ADMINISTRATIVE STAFF REPORT

Project Name: Smith Critical Area Buffer Reduction

Type of Application: Critical Area Buffer Reduction (Type II)

Permit Number: 22-00076

6. Site Design

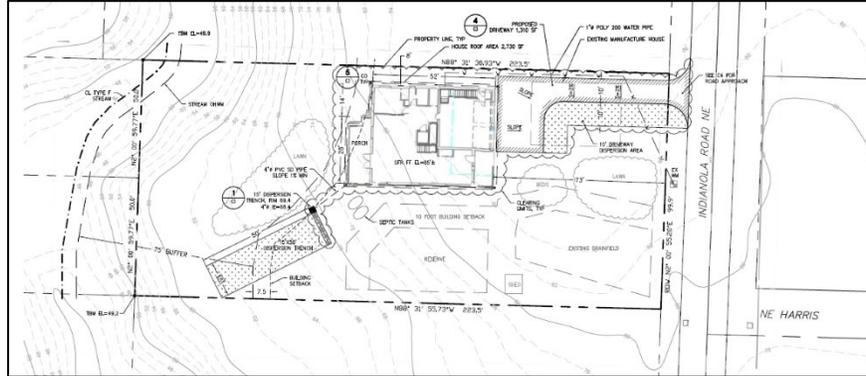
The image below shows the proposed footprint of the home and associated drainfield as well as the existing driveway. On site is an existing home which will remain during construction and then be rebuilt as a garage in its place. The site plan also shows the location of the onsite Type F stream to the west.

Site Plan

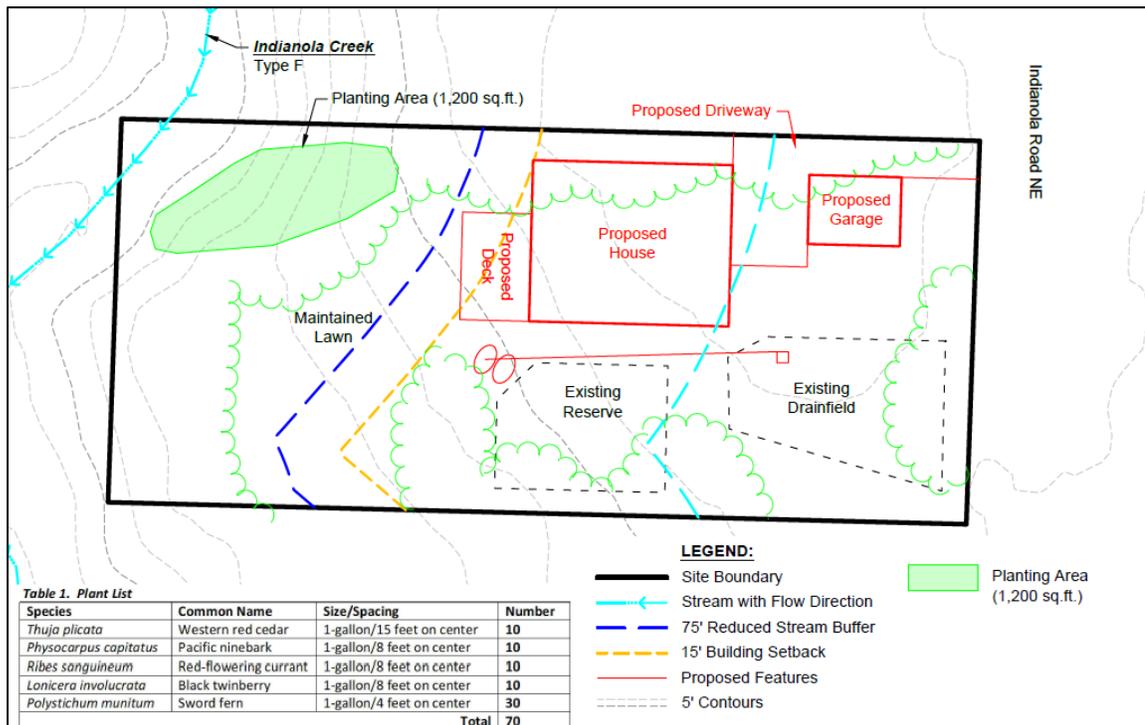
5. *No other practicable or reasonable alternative exists. (See Definitions, Chapter 19.150.)*

Response: Some amount of buffer reduction is necessary to accommodate any single-family development on this lot. The home is utilizing an existing drain field limiting the ability for the home or driveway to be located elsewhere on the property. It does not appear that practicable alternatives exist to the proposed site design.
